SHOP DRAWING REVIEW

GIRDER G12R
VT 78 OVER MISSISQUOI BAY, BRIDGE NO. 2
VT 78 STA.10+970.425 TO STA.12+059.775
TOWNS OF ALBURG AND SWANTON
COUNTIES OF GRAND ISLE AND FRANKLIN
STATE OF VERMONT, AGENCY OF TRANSPORTATION

STATE CONTRACT OR REF. NO. BRF-036-1(1)
CONTRACTOR CIANBRO CORPORATION
IN CHARGE: GLIDDEN (IH) MADE BY: SSL CHK'D. BY: CS DATE: 8-24-04
CONTRACT NUMBER: VT-04057-3 DRAWING NUMBER: 72 OF 112

GIRDER ~ G12R

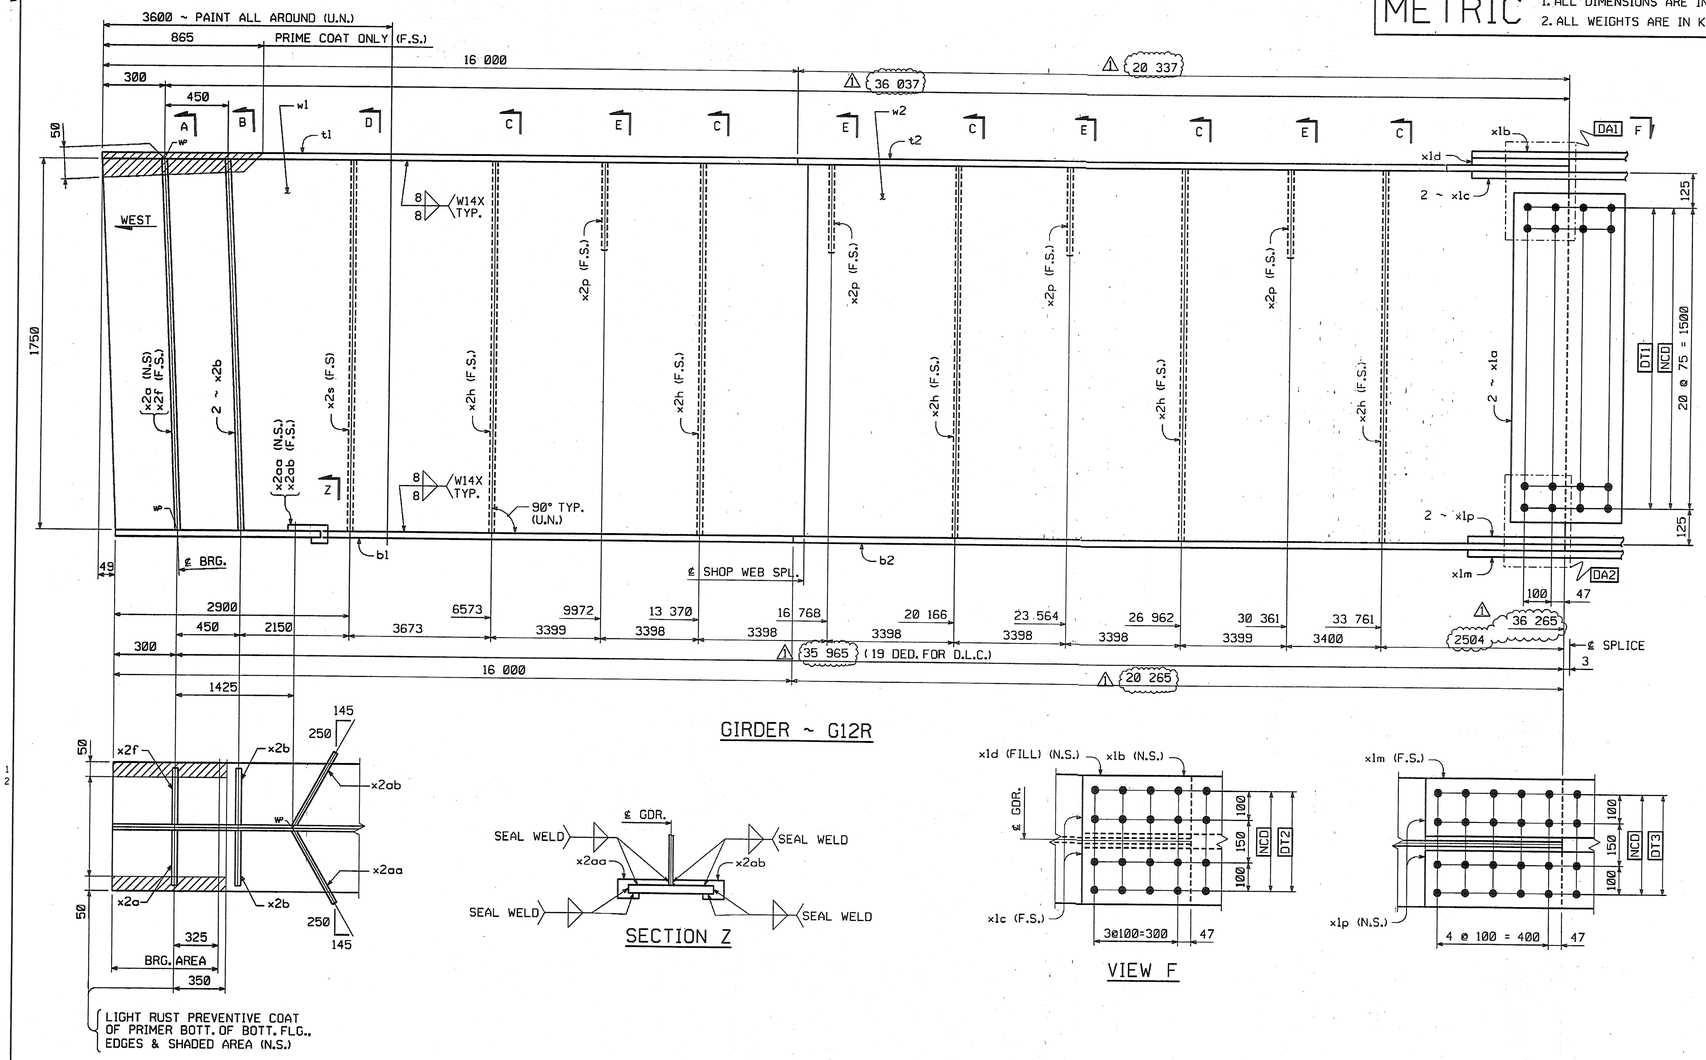
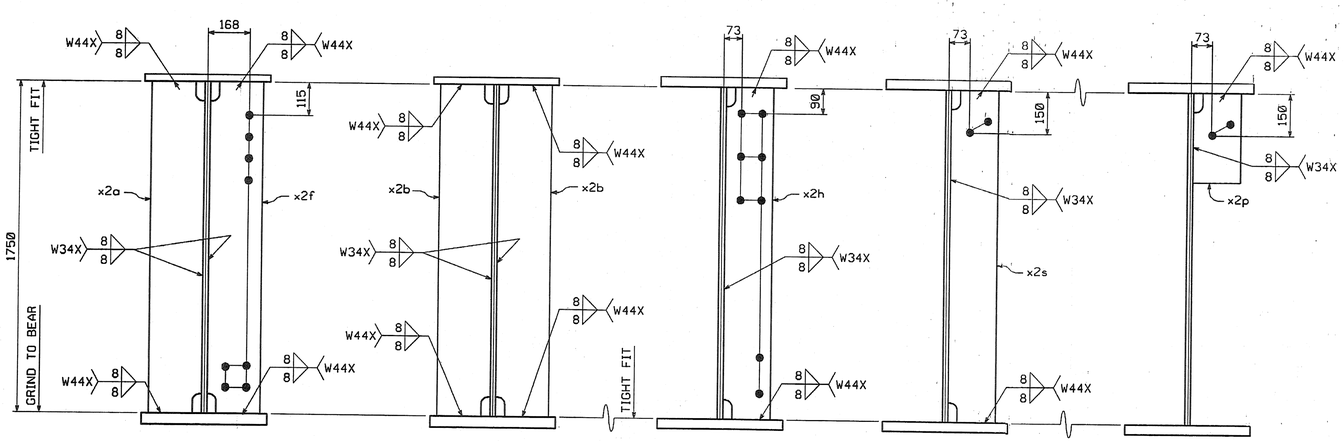
NO.	MARK	DESCRIPTION	LENGTH	REMARKS	GRP.	ITEM	SHIP. WT. KG. EA.	
ONE	G12R	GIRDER					16 730	
~~1~~	~~w1~~	~~PL 16 x 1750~~	~~16 342~~	~~(T)~~	~~3~~	~~10~~	~~3591.56~~	
1	w2	PL 16 x 1750	~~19 996~~	(T) 36301	3	8	~~4394.62~~	7978.96
1	t1	PL 22 x 450	~~16 001~~	(T) 16000	4	28	~~1243.38~~	1243.44
1	t2	PL 22 x 450	20 337	(T)	4	26	1580.31	1580.49
1	b1	PL 40 x 450	~~16 001~~	(T) 16000	4	5	2260.68	2260.80
1	b2	PL 40 x 450	20 265	(T)	4	4	2863.12	2863.44
2	x1a	PL 12 x 1600	400	(T)	6	1	~~60.28~~	120.58
1	x1b	PL 14 x 450	790	(T)	6	6	~~39.06~~	39.07
2	x1c	PL 16 x 200	790	(T)	6	5	~~19.84~~	39.69
1	x1d	PL 18 x 450	392	FILL	6	4	~~24.92~~	24.93
1	x1m	PL 18 x 450	990	(T)	6	3	~~62.94~~	62.95
2	x1p	PL 20 x 200	990	(T)	6	2	~~31.08~~	62.17
1	x2a	PL 22 x 200	1 750		7	2	~~60.44~~	60.45
2	x2b	PL 22 x 200	1 750		7	2	~~60.44~~	120.89
1	x2f	PL 22 x 200	1 750		7	2	~~60.44~~	60.45
5	x2h	PL 12 x 180	1 750		7	4	~~29.67~~	148.37
4	x2p	PL 14 x 180	310		7	3	~~6.13~~	24.53

1	x2s	PL 12 x 180	1 750		7	4	29.67	
1	x2aa	PL 6 x ~~90~~	301	*V=1=72150mm³	7	5	~~1.28~~	0.57
1	x2ab	PL 6 x ~~90~~	301	" " "	7	5	~~1.28~~	0.57

TOTAL WEIGHT THIS SHEET: ~~16729.85~~ kgs

* SEE SHEET 1 OF 112 (16722.02 kg) EMR 08-21-06

NO.	REVISION	BY	DATE
1	INCREASE LENGTHS TO SATISFY REQUIREMENTS FOR LENGTH @ MEAN TEMPERATURE OF 45°F.	DP	9/20/04

☒ REVIEWED AS REQUIRED BY THE CONSTRUCTION CONTRACT DOCUMENTS AND APPROVED, BUT ONLY FOR CONFORMANCE TO THE DESIGN CONCEPT OF THE WORK, AND SUBJECT TO FURTHER LIMITATIONS AND REQUIREMENTS CONTAINED IN THE CONSTRUCTION CONTRACT DOCUMENTS.
☐ REJECTED ☐ REVISE AND RESUBMIT ☐ FURNISH AS CORRECTED
